State of New Mexico
Energy, Minerals and Natural Resources Department

30-039-06628 BREECH A #135

Re: Permanent Abandonment
Well: Breech A 135 API: 30-039-06628

P&A Procedure

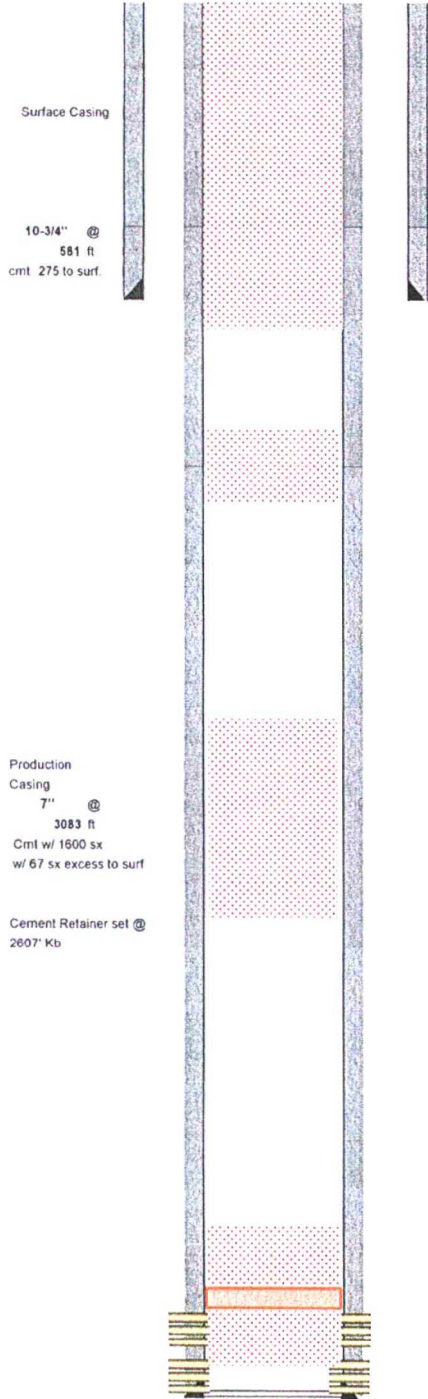
- Notify NMOCD 24hrs prior to beginning operations.
- Keep proposed Plug #1, plus BLM COA.
- Add a plug from 2,990'-2,840' to cover the Fruitland top. OCD Fruitland pick @ 2,890'
- Adjust plug #2 to 2,640' – 2,175' to cover the Kirtland, Ojo Alamo and BLM Fruitland tops. OCD Ojo Alamo pick @ 2,370'; OCD Kirtland Pick @ 2,590'.
- Add plug 1,435-1,335' to cover the Nacimiento top, plus BLM plug. OCD Nacimiento pick @ 1,385'.

1. Plugging operations authorized are subject to the "General Requirements for Permanent Abandonment of Wells on Federal and Indian Lease."
2. Farmington Office is to be notified at least 24 hours before the plugging operations commence (505) 564-7750.
3. CBL required after setting CIBP from 3035' to surface to confirm TOC. Submit electronic copy of the log for verification to the following addresses: jhoffman@blm.gov and Brandon.Powell@state.nm.us . Based on CBL results inside/outside plugs and volumes will be adjusted accordingly. Please review the General Requirements document to ensure volumes meet required excess inside and outside casing.
4. BLM picks formation tops as indicated in the table below for use in determining TOC for all plugs.

<u>Top</u>
Nacimiento	1180
Ojo Alamo	2225
Kirtland	2340
Fruitland	2580
Pictured Cliffs	2940
